REMARKS

Applicant has carefully reviewed the Official Action dated August 30, 2001 and this Amendment is intended to be fully responsive to the Action.

"MOTOR-VEHICLE WINDOW LIFT WITH RIGIDLY COUPLED ACTUATORS IN THE
LIFT-OPERATING POSITION" to

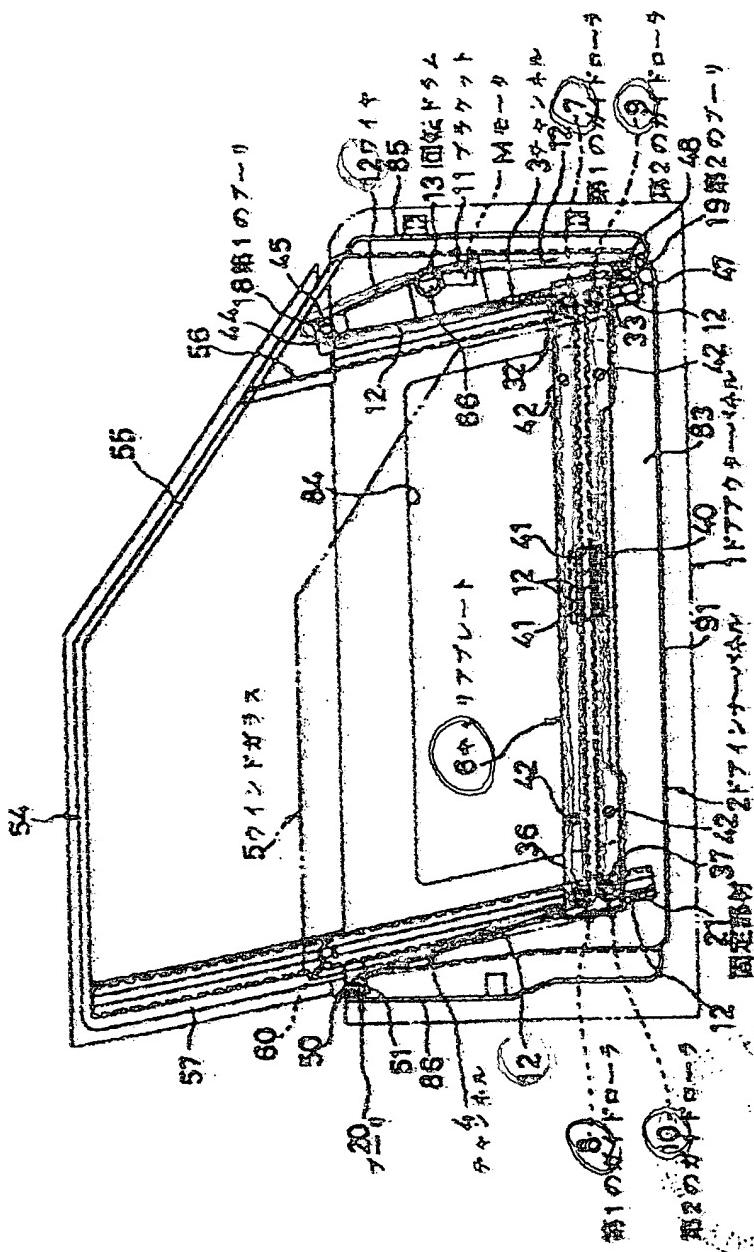
The drawings were objected to because Figure 3 includes the same reference numeral "14" to denote different components. Applicant has submitted a drawing correction to Figure 3 changing "14" to --14"-- intended to overcome this objection. The specification was also amended to correctly denote elements "11" and "14". No new matter has been entered.

Fig. 3 shows an alternate embodiment with the mounting structure 2'' consisting of several parts and illustratively includes a sheetmetal support 15'' for the drive means 4'', for the braces 17'' supporting the reversing rollers 10'' and further sheetmetal support for instance to affix one or possibly two guides 6'', 7''.

With respect to [As regards] the embodiment of Fig. 3, the mounting structure 2 consists of several parts and illustratively includes [a] sheetmetal supports 15'' for the drive means 4'', for the braces 17'' supporting the reversing rollers 10 and further [support sheetmetals]
sheetmetal supports for instance to affix one or possibly two guides 6'', 7''. Otherwise the design is similar to that of the other embodiments. The embodiment shown in Fig. 3 also makes it easily possible to guide only one of the two actuators 12'', 13'' in a guide 6'', 7'' and to affix the other actuator in unguided manner to the corresponding cable segment 3'', 5''. The elimination of a guide 6'', 7'' for one of the two actuators 12'', 13'', or slide elements, however does not entail a significant reduction of the stability, i.e. guidance properties of the window lift of the invention because the two actuators 12'', 13'', or slide elements, are connected to each other by the rigid coupling 11'', i.e. the crossbar 14''.
